Intel® Desktop Board D815BN Specification Update

Release Date: May 2001

Order Number: A42948-004

Figure 1. D815BN Board Components

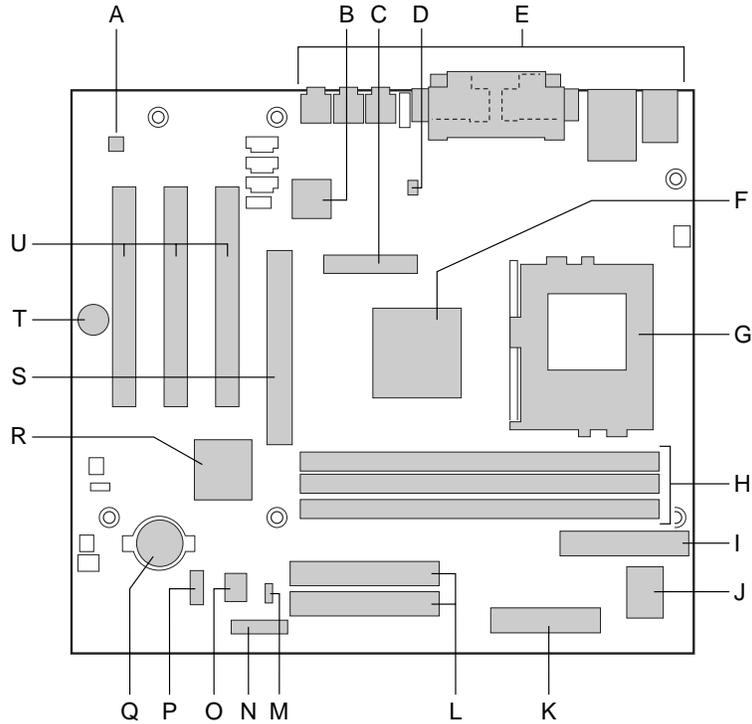
4. Change to Description of Section 1.1.3, D815BN Board Layout, Figure 1

Section 1.1.3, D815BN Board Layout, Figure 1 will change in its entirety as follows:

| D | Hardware monitor (optional) | O | Intel® 82802AB 4 Mbit Firmware Hub (FWH) or the STM* M50FWH040 4 Mbit Firmware Hub (FWH) |
